Appln No. 10/733,824

Reply to Office action of October 27, 2004

REMARKS/ARGUMENTS

Fig. 19

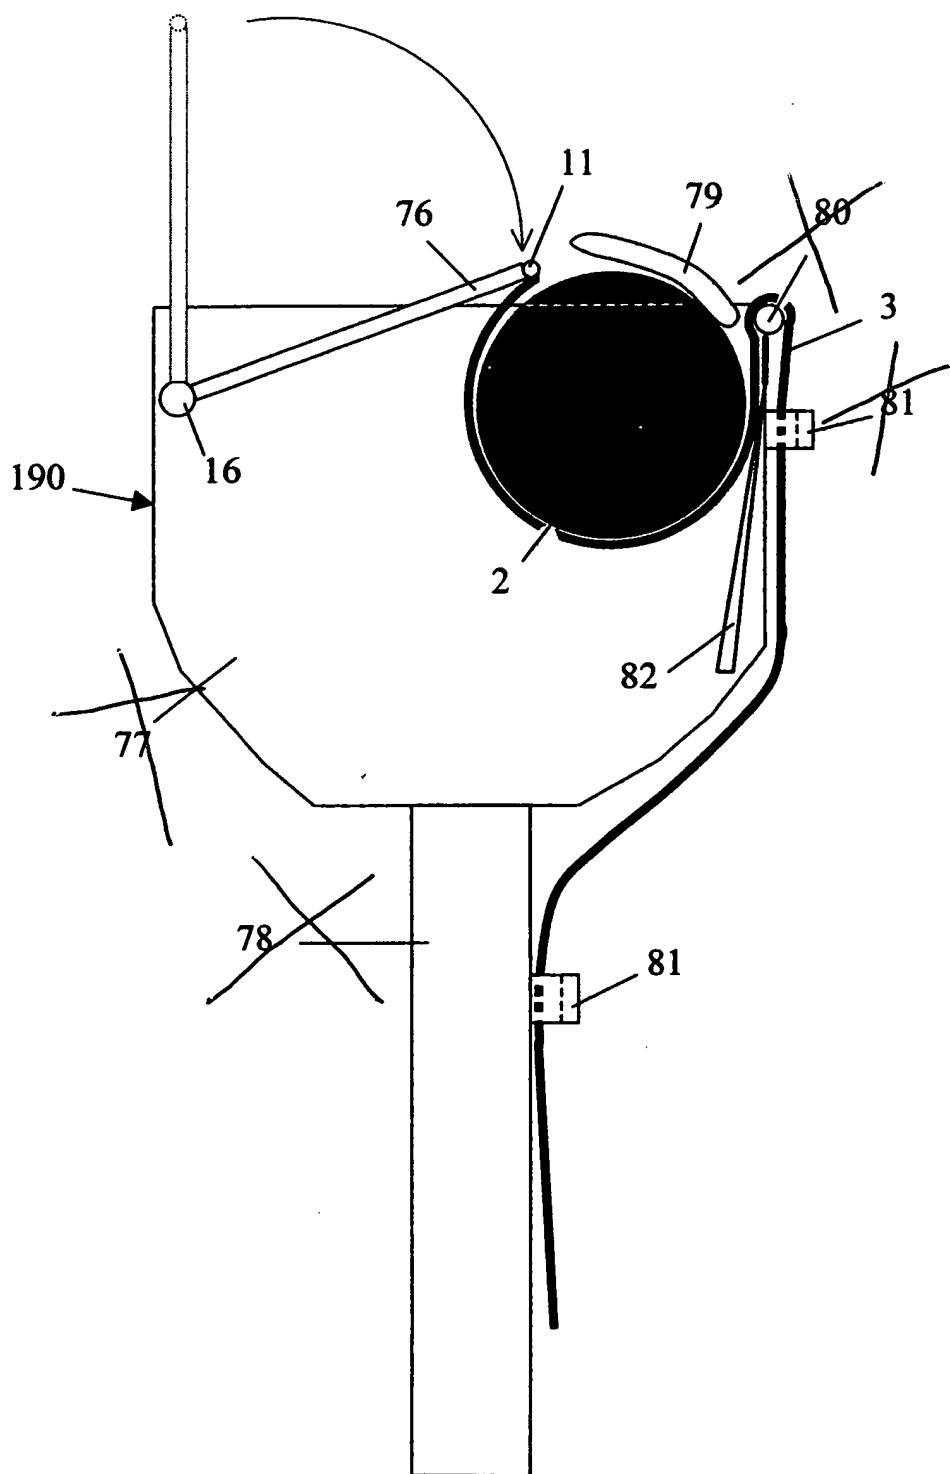
Lastly, with reference to the drawings, the Examiner objects to FIGS. 7, 19, 20 and 23 under 37 CFR 1.84 (p)(4) & (5). The sheets bearing FIGS. 7, 19 and 23 are replaced with sheets bearing replacement FIGS. 7, 19 and 23. In replacement FIG. 7, the reference line is amended to point to the leading edge of the rocker arm. In replacement FIG. 19, reference numerals 77, 78, 80 and 81 are removed, and in replacement FIG. 23, reference numerals 91, 92 and 93 are removed. In the specification, reference numeral 9 is replaced by reference numeral 76 so reference numeral is not added to FIGS. 19 and 20. With these amendments, the 37 CFR 1.84 (p)(4)& (5) grounds of objection fall away.

The attached sheets of drawings includes changes to 7, 19 and 23. These sheet, which include FIGS. 7, 19 and 23, replaces the original sheets including FIGS. 7, 19 and 23.
